CNWRA COMMENTS ON DRAFT NUREG-2230 (08/09/2019)

Center for Nuclear Waste Regulatory Analyses (CNWRA®) staff completed a detailed review of draft NUREG-2230, “Methodology for Modeling Fire Growth and Suppression Response for Electrical Cabinet Fires in Nuclear Power Plants” dated June 2019 (hereafter referred to as “draft NUREG-2230”) for the Office of Nuclear Reactor Regulation (NRR) of the U.S. Nuclear Regulatory Commission (NRC). Two types of comments resulted from this review. The first type involves substantive and technical comments, which are discussed first below. This is followed by a list of some editorial comments. Finally, it is proposed that the Monte Carlo simulation described in Appendix B is redone. A proposed revision of Appendix B can be found in Attachments B and C.

Figure B-1
Alarm threshold OD gamma distribution fit

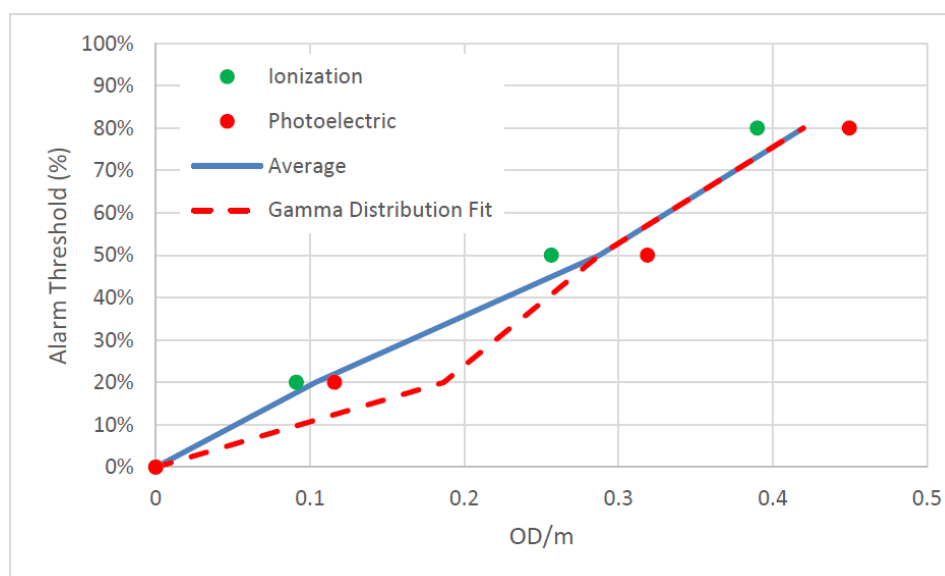
- Because it is not necessary to calculate the time of smoke detector activation, the HRR profile duration parameters can be deleted.
- Figure B-1 in Section C.2 indicates that a gamma distribution is not a particularly good fit. A better-fitting distribution should be used.

Figure B-2
Results comparing NIST home smoke detector activation times with OD modeled activation times

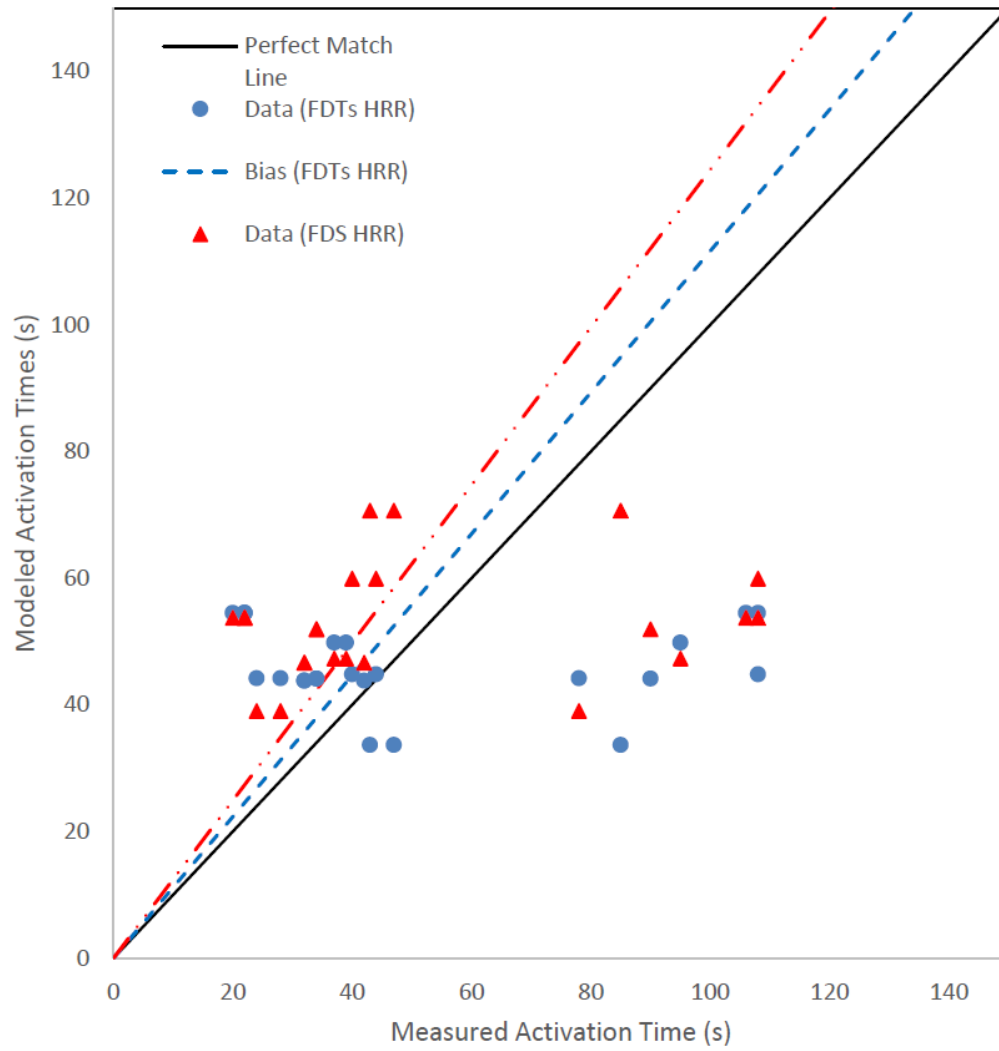
It is proposed that this section be deleted. As mentioned in the comment on Page B-1, lines 13-14, to determine whether a smoke detector will actuate for a set of sampled parameters it is not necessary to calculate the time to activation. Consequently, an evaluation of the capability of models to predict smoke detector activation time has little or no bearing on the validity of the results of the Monte Carlo simulation. Moreover, Figure B-2 indicates that the predictive capability of the two models is very poor. More work is needed to investigate the reasons for the discrepancies and to improve the predictive capability of the models.
